Subject: EPA Comments on Kansas City Board of Public Utilities, Nearman Creek Power Station, Kansas City, KS
Round 7 Draft Assessment Report

**Subject: Comments on Draft Coal Combustion Waste Impoundment Round 7 –
Dam Assessment Report (Site #009), Nearman Creek Power Station,
Coal Ash Pond Dike, Kansas City Board of Public Utilities, Kansas City,
Kansas**

Coal Combustion Waste Impoundment Round 7 - Dam Assessment Report (Site #009)

Nearman Creek Power Station
Coal Ash Pond Dike
Kansas City Board of Public Utilities
Kansas City, Kansas

Figure 4.2.1-1: Configuration of the Ash Pond at the KCBPU Nearman Creek Facility

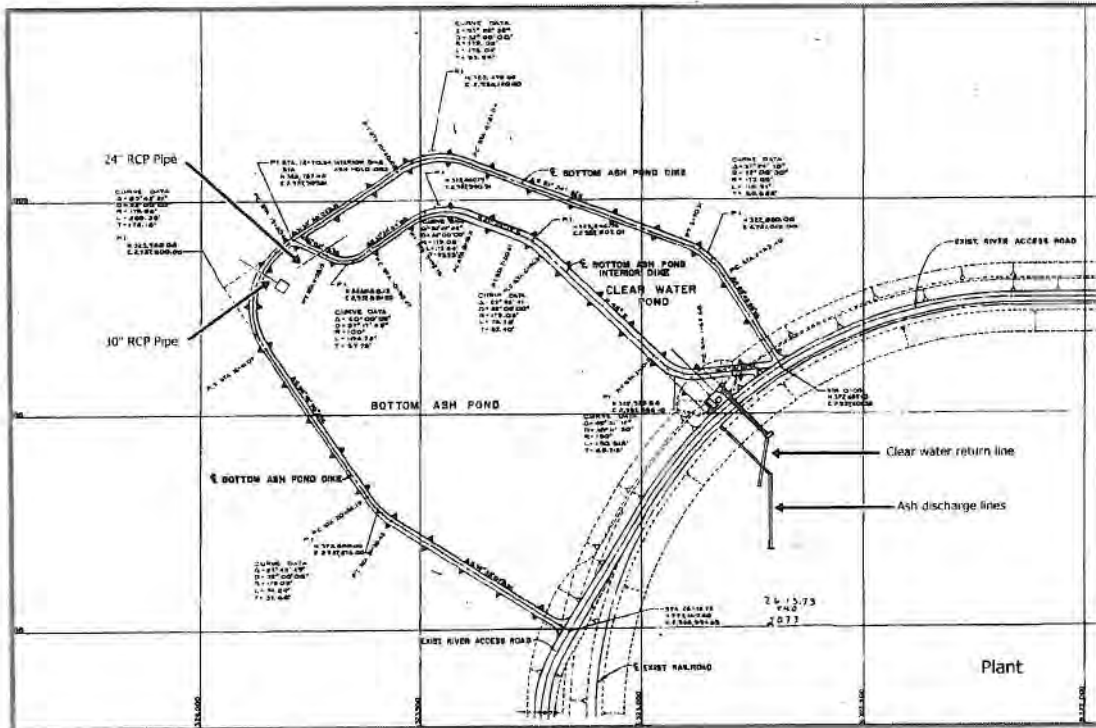
See page 5-2 +++
?

Terrecon Report!!
